STAFF REPORT RECOMMENDATION

FILE NUMBER: TP 17-02: Parker Knoll

REQUEST: The applicant is seeking approval of an eleven-lot Subdivision in the “R-8” Single-Family Dwelling District and “I” Institutional District. A portion of the subdivision road access will be accommodated within a 50-foot wide easement in Wesley Lynn Park.

LOCATION: 19510 Leland Road, Oregon City, OR 97045
Clackamas County Map 3-2E-07D, Tax Lots 600, 601, 700, 701, 501, and 401

Figure 3: Proposed Site Plan

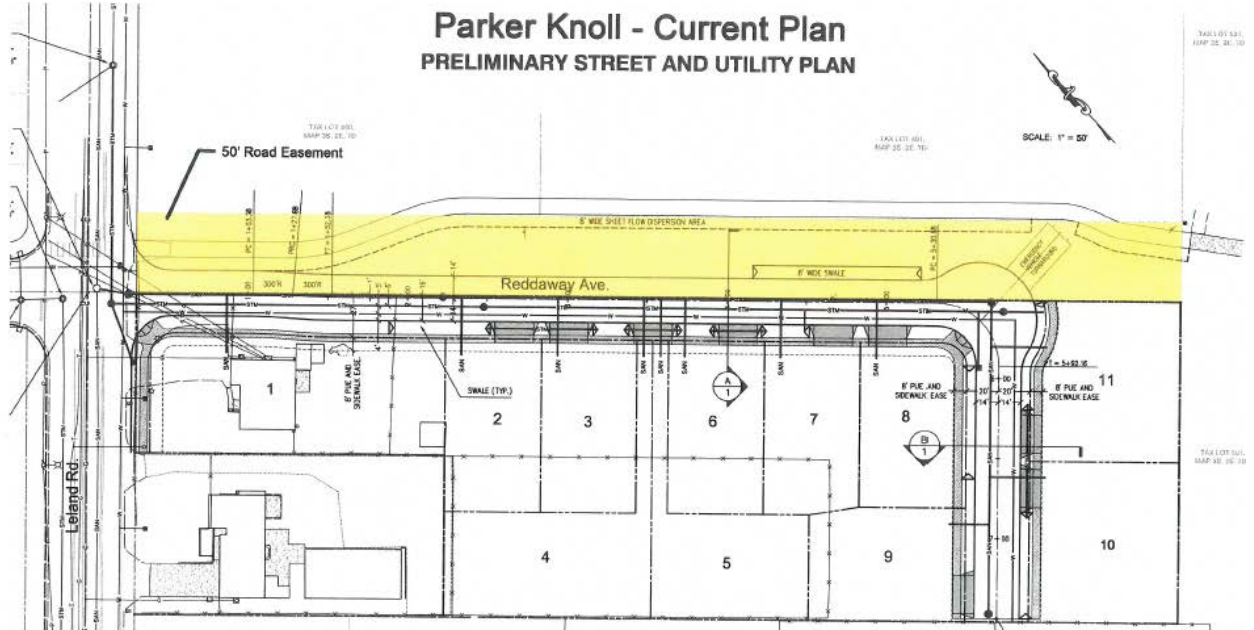
The applicant proposed to utilize an existing easement (shown below in yellow) to accommodate a portion of the roadway on the Wesley Lynn Park property. Though the easement grants the applicant rights to develop a portion of Wesley Lynn Park, according to the Oregon City Charter, certain development of park property requires approval of Oregon City voters. The easement area has twice been the subject of election proposals that would have allowed locating a roadway, drainage and utilities necessary to support the development on park land. As the elections both were narrowly defeated, the applicant revised the design to include a public road within a portion of the easement as well as a concrete path, both within

and outside of the easement area, which they believe is authorized by the easement and does not require voter approval.
